Certified Action of the City of Raleigh Planning Commission

Case File / Name: SP-67-11 / Edison Apartments

SP-67-11 Edison Apartments – Preliminary Site Plan

Staff Report

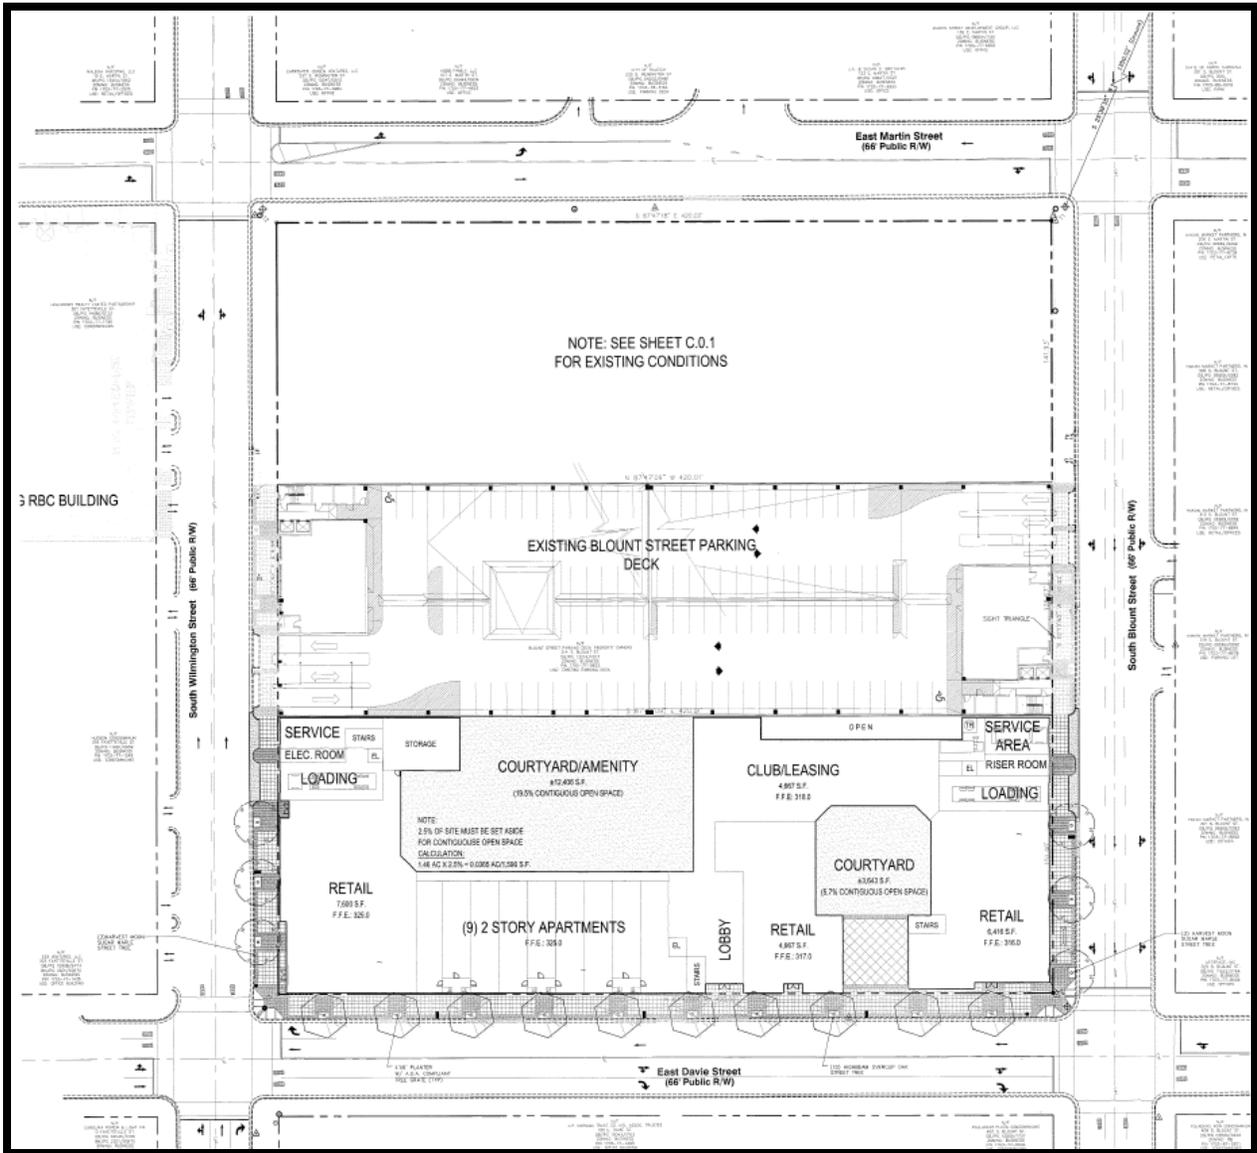
<u>Comment</u>	<u>Response</u>
Although the site is adjacent to, rather than located in, the Moore Square Historic Overlay District, it is within the Moore Square National Register Historic District. Both Moore Square and much of Fayetteville Street are characterized by storefronts and building entrances on a very human scale.	Acknowledged
The mid-rise scale of the building is consistent with other buildings in the vicinity.	Acknowledged
The commission appreciates the alcove stoops which bring residential entrances to the street level.	Acknowledged
This building's ground level design includes first floor window bays with canopies in order to enhance a pedestrian-scaled ground floor.	Acknowledged
In keeping with the pedestrian scale and to engage the buildings across Blount Street and activate that elevation, the commission strongly encourages the addition of entrances	There will likely be entrances to the eastern retail space on Blount Street, however, these would be added by retail tenants as yet undefined. There will be an entrance on the corner of the

The commission also suggests that brick should be used as the exterior material as much as possible as a way to visually connect to the historic district and provide scale.

<u>Comment</u>	<u>Response</u>
The Appearance Commission wishes to commend the applicants on the revisions to the previously-submitted elevations, particularly the improved quality of the building materials, thought given to design and placement of building elements, and increased attention to the pedestrian realm.	Acknowledged
Given the visual and functional prominence of the proposed storefront at the Davie/ Wilmington corner, the commission recommends that its design be detailed further; e.g., re-envision the corner pier/ column as an iconic element (perhaps executed even as artwork), and link individual canopies into a continuous wrap-around form [commensurate with Code Sec. 10-2132.2(d)(2), and Downtown Design Guidelines 6, 20, 28, & 39].	This will be considered as the design develops.

building at Blount and Davie Streets. There will also be a secondary pedestrian entrance for residents of the building that will open to Blount Streets. Brick is the dominant material on the exterior faces of the building. There are additional details and cast stone banding at the pedestrian level to enhance tactility, and provide a sense of scale. Metal and cementitious paneling is also used.
